Safety Evaluation Report

Related to the License Renewal of the Joseph M. Farley Nuclear Plant, Units 1 and 2

Southern Nuclear Operating Company, Inc.

U.S. Nuclear Regulatory Commission

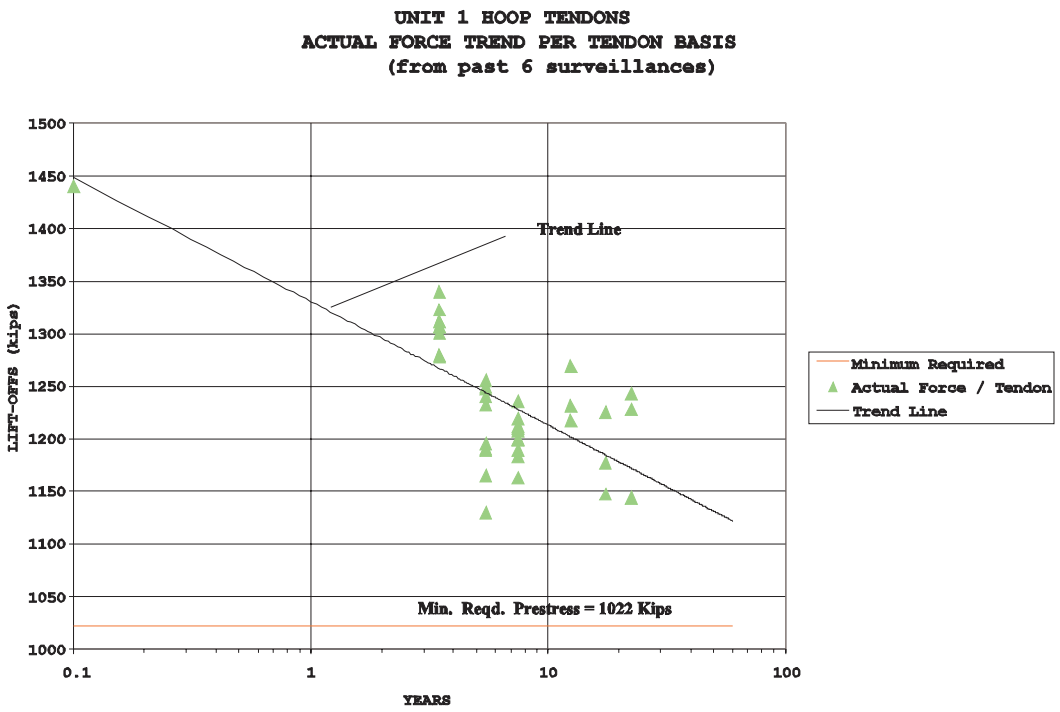
The staff recognizes that subsequent inspections could result in a change in the trend line slopes. However, the applicant will manage this attribute by its Containment Inservice Inspection Program. On the basis of the additional information provided by the applicant, as well as the staff's evaluation, the staff considers the applicant's TLAA related to prestressing forces in the prestressing tendons of the FNP containment to be acceptable.
